Permittee: Montanore Minerals Corporation
Operating Permit #: 00150
Location: Libby, Lincoln County
Date: May 2022, Revised August 2022, Revised December 2022

This minor permit revision request follows the format of Administrative Rules of Montana ARM 17.24.120 of the Rules and Regulations Governing the Montana Hard-Rock Mining Reclamation Act.

Montanore Minerals Corporation (MMC or Company) prepared this minor permit revision to Hard Rock Operating Permit No. 00150 for the Libby Exploration Project (Project). MMC holds Operating Permit No. 00150 authorizing completion of the Libby Adit and construction, operation, and reclamation of the Project. Exploration activities were authorized at the Libby Adit Site in Exploration License No. 00429, issued on April 19, 1989. The license was later incorporated into Operating Permit No. 00150 issued in 1993. Since then, minor revisions have been authorized by the Montana Department of Environmental Quality (DEQ) as follows:

K WASTE ROCK REPOSITORY #2 STACKING PLAN

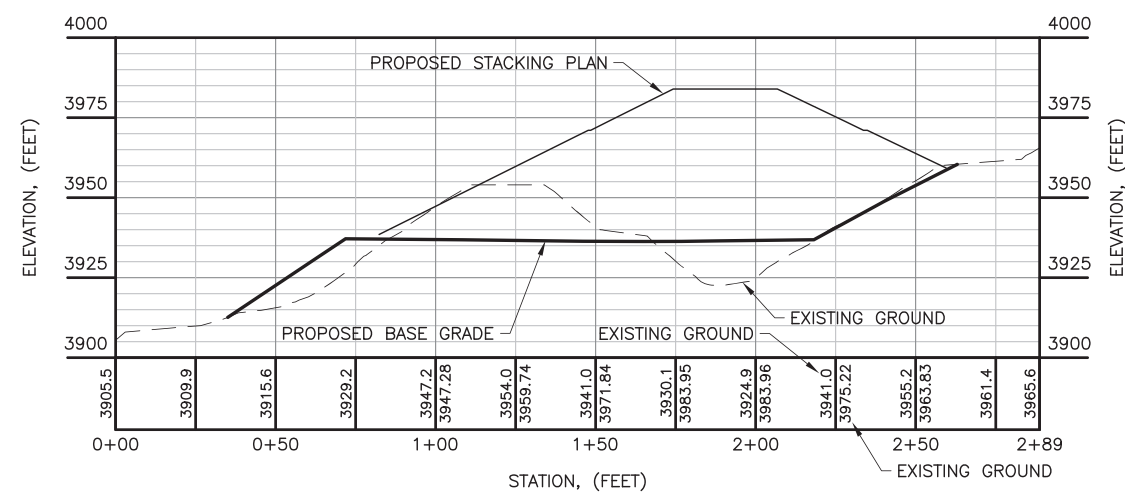
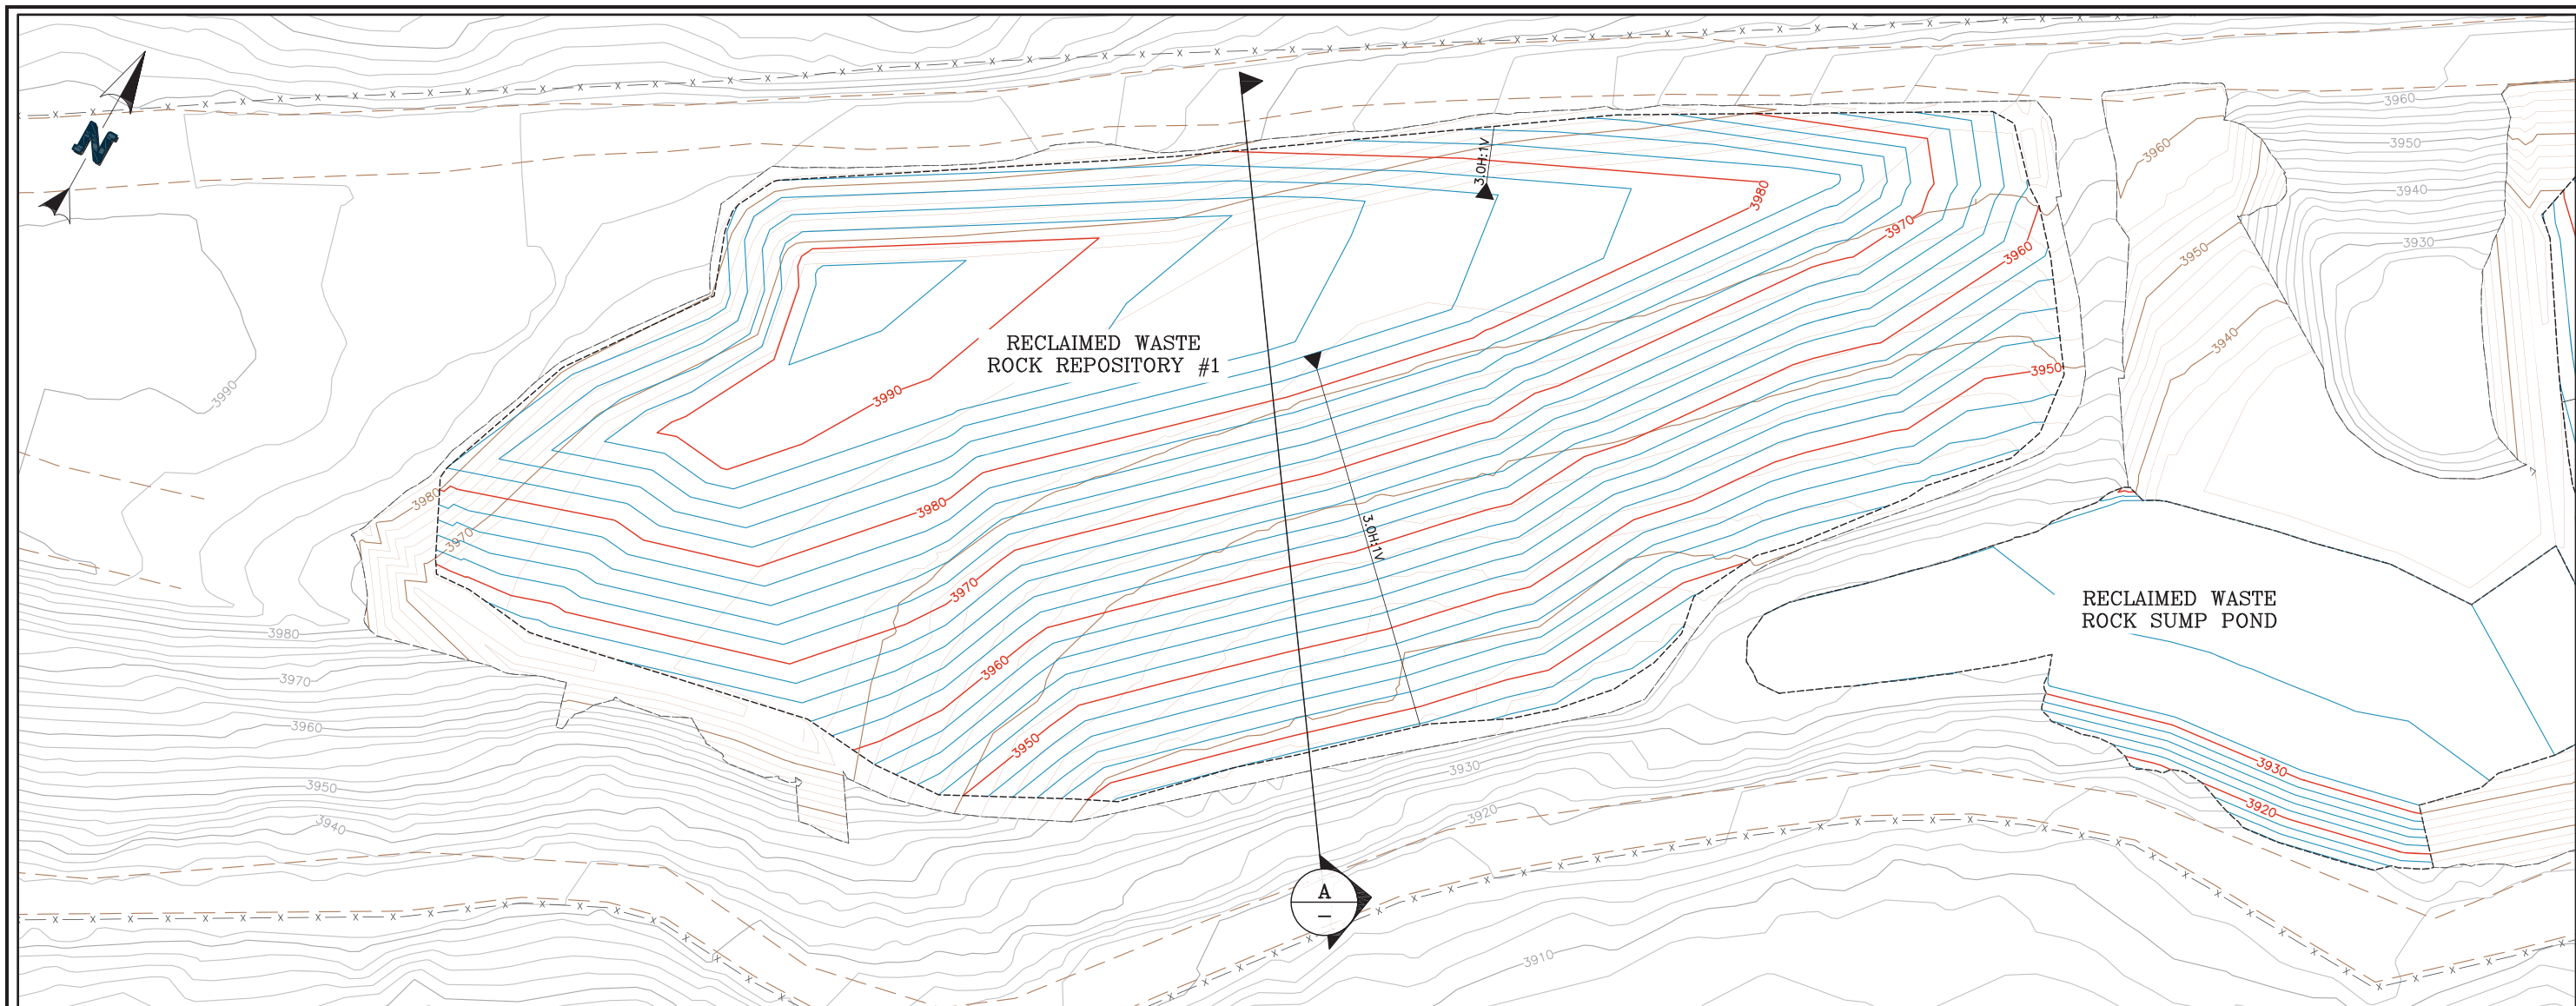
MMC will also expand the authorized footprint of WRSA #2 (MMC has yet to place waste rock in WRSA #2). WRSA #2 will include installation of a HDPE liner and have a storage capacity of approximately 87,000 yd³. A plan view and cross-section of WRSA #2 is shown on **Figure 3**.

C WRR1 COLLECTION PIPES TO SUMP POND

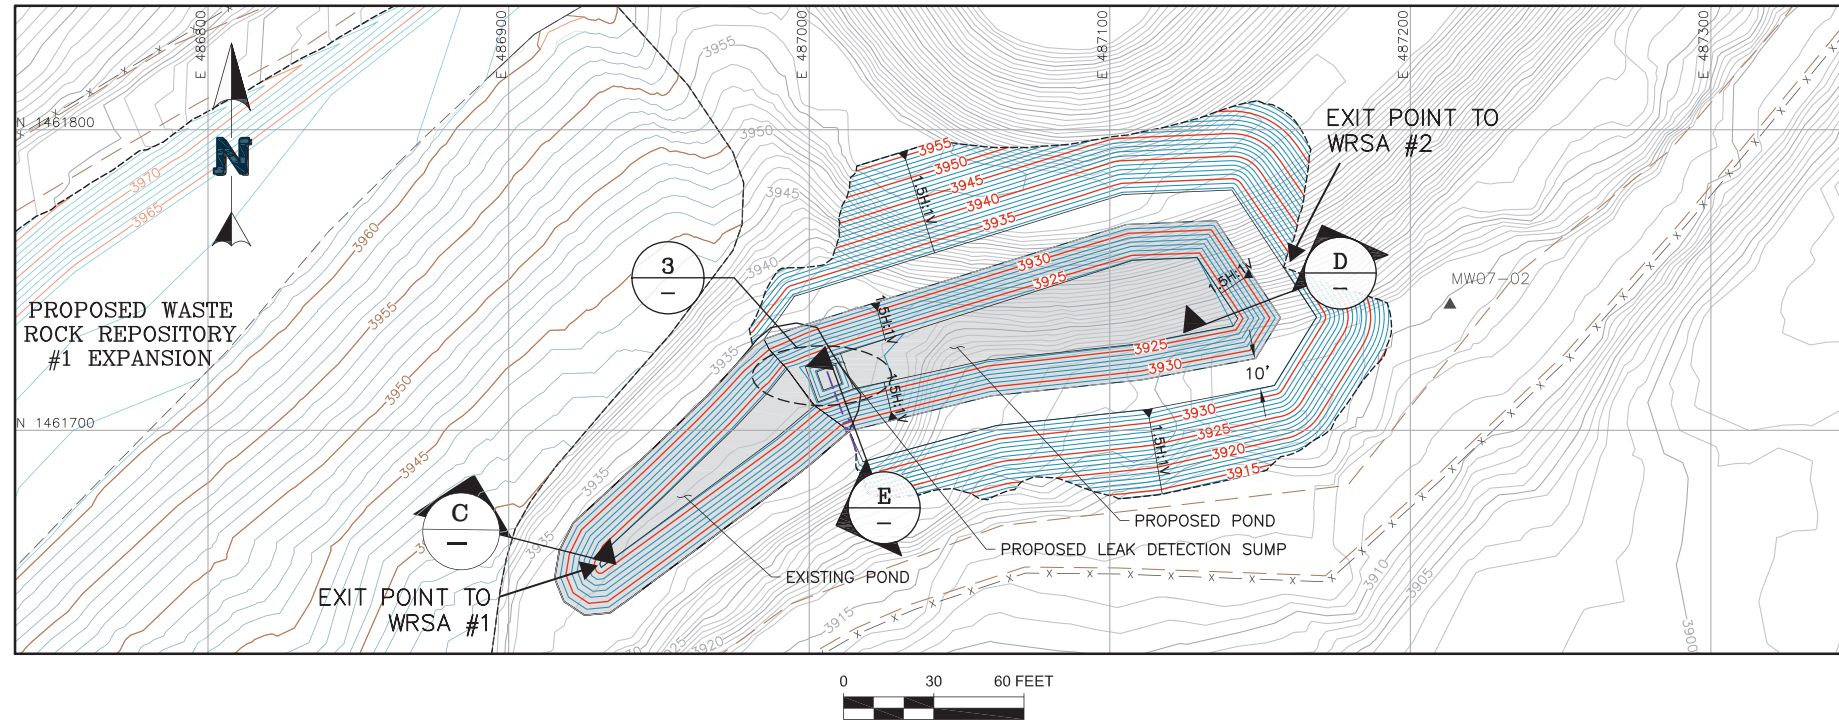
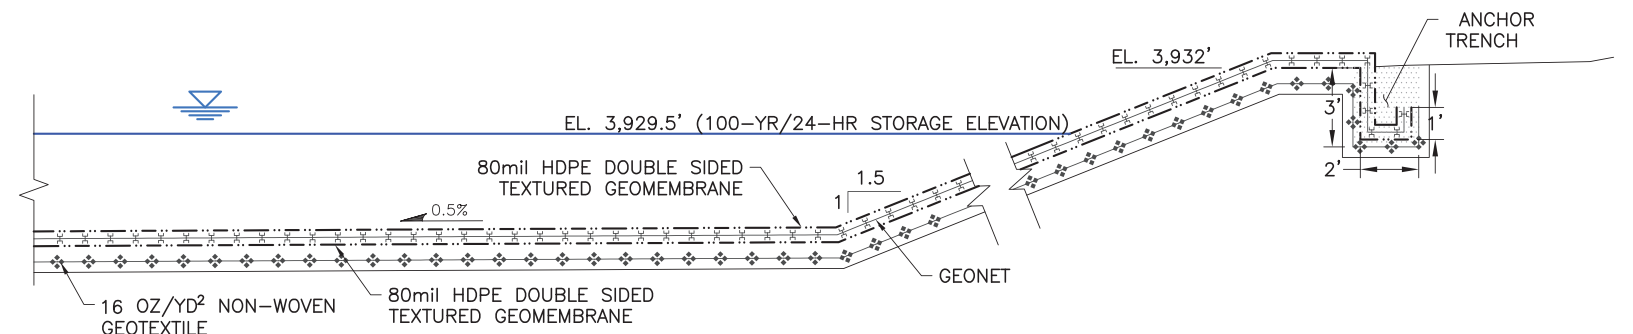
MMC will construct a new 360,000-gallon capacity WRS to replace the existing 75,000-gallon-capacity single liner sump (**Figure 6**). Runoff from the WRSAs and precipitation that infiltrates to the liner below the facilities will be directed to the lined WRS. The WRS will be double-lined with 80-mil HDPE liner and include a leak detection system. Water collected at the WRSAs will be directed, via exit points, to the WRS which is sized to manage runoff from a 100-year, 24-hour storm event. The exit points are located at both ends of the WRS. WRSA #1 flows in from the west with two existing pipes; WRSA #2 flows in from the east with new, proposed pipes. **Figure 6** shows the exit points for WRSA #1 and WRSA #2. A cross section of the collection pipes from WRSA #1 to the WRS is shown on **Figure 6**.

Libby Adit Site Extension and Drift Construction
 Libby Exploration Project
 Lincoln County, Montana
 FIGURE 8

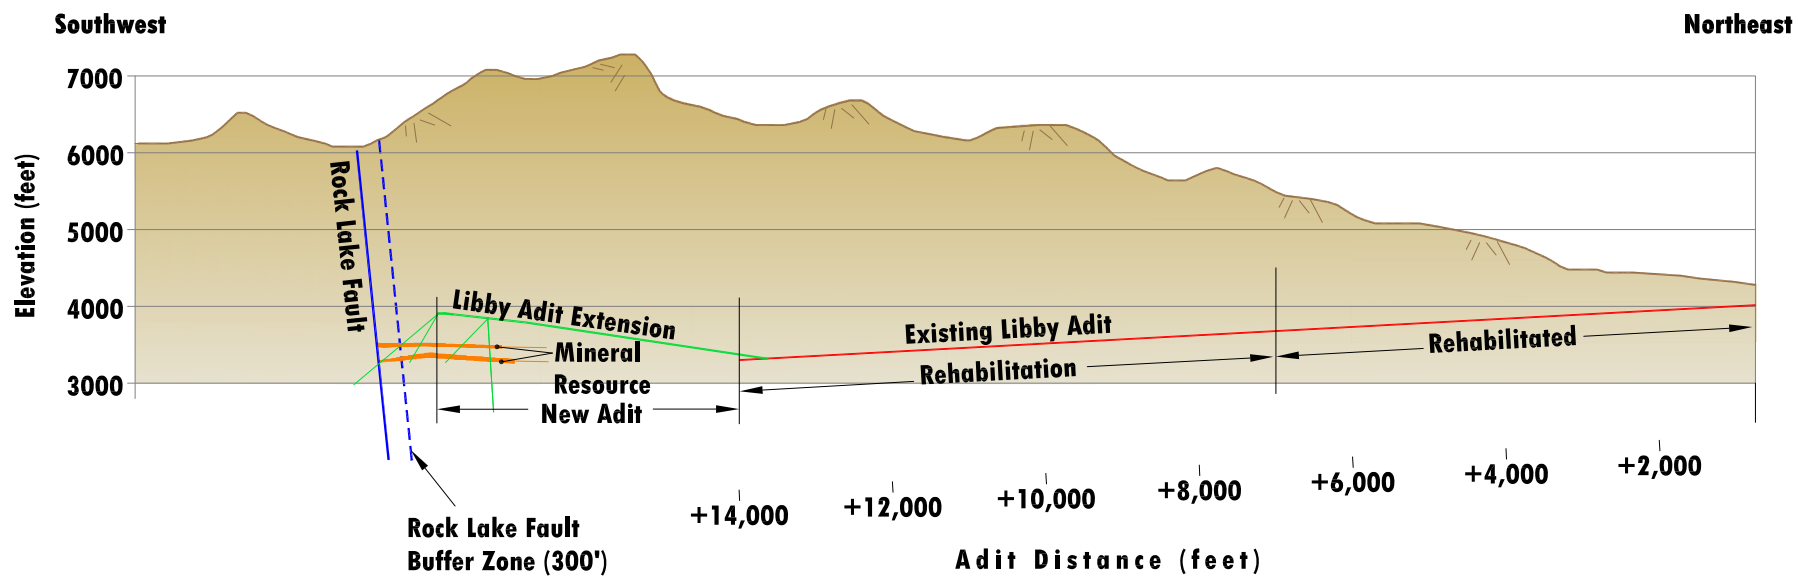
Once the existing Libby Adit is dewatered and rehabilitated, MMC will begin underground construction to extend the existing adit and establish drill stations. Previous plans and layout for underground drifts under MR 06-002 included construction of underground workings to reach an area below the mineral resource. MMC will modify the underground drifts layout to conduct exploration from drill stations located above the mineral resource. MMC will construct an inclined adit extension to above the currently defined resource along with lateral drifts (**Figure 8**).

The revised underground layout will include constructing an extension of the Libby Adit by approximately 4,200 feet and constructing 6,300 feet of drifts to conduct exploration activities. Underground construction under MR 06-002 consisted of extending the Libby Adit by 3,300 feet and construction of 7,100 feet of drifts. This minor revision will add 900 feet of adit and subtract 800 feet of drifts (**Figure 9**). The proposed design changes for the underground development will generate an estimated 135,000 yd³ of waste rock material. The underground lateral drifts proposed in this Minor Revision are reduced to 15x15 feet drifts compared to 18x18 feet as presented in MR 06-002.

Underground Construction and Exploration Schematic
Libby Exploration Project
Lincoln County, Montana
FIGURE 9

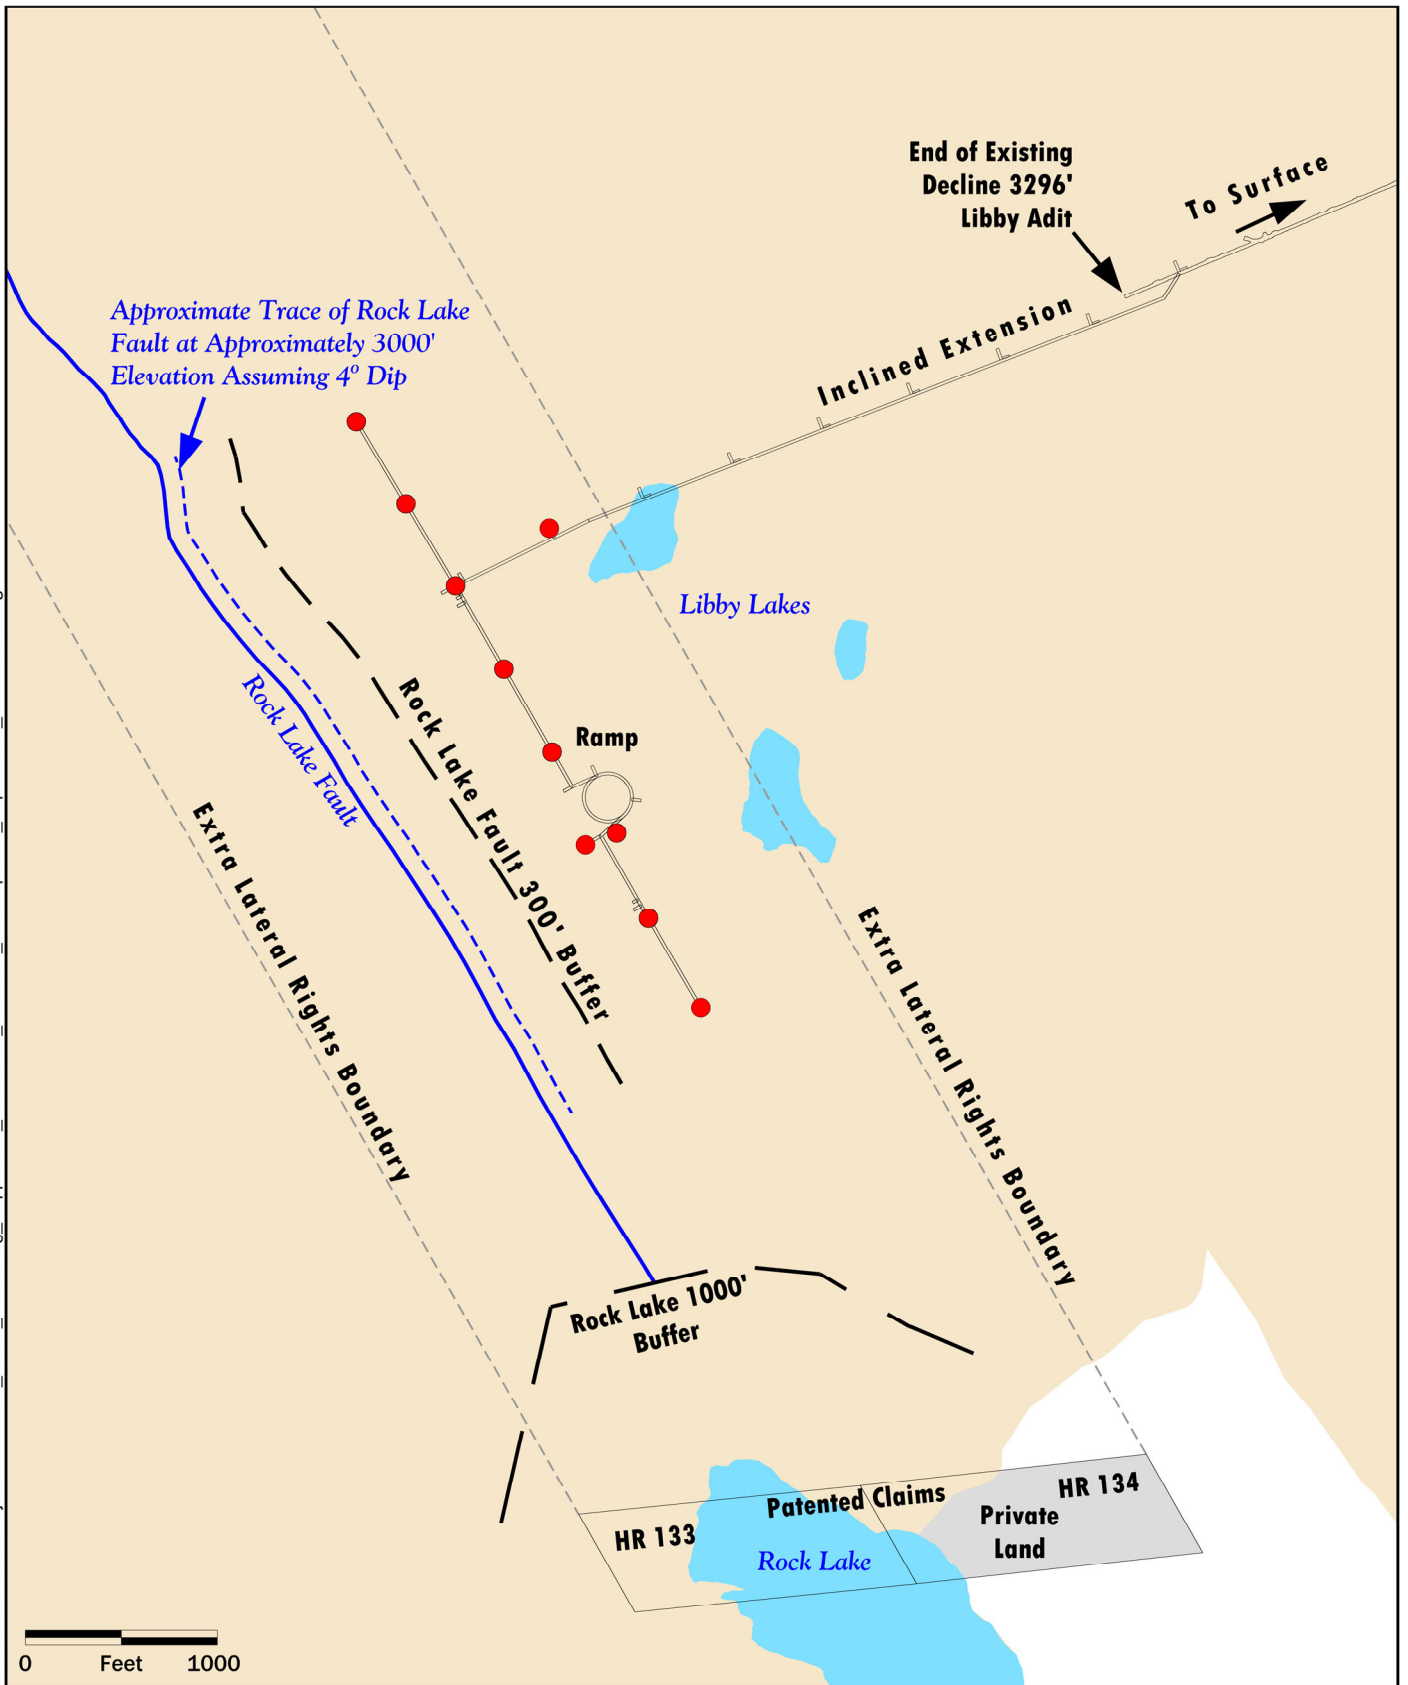
Modification for the underground drilling program consists of new underground drill locations (above the mineral resources instead of below the zone). MMC will conduct mineral exploration from approximately 35 underground drill stations located in drifts above the mineralized zone.
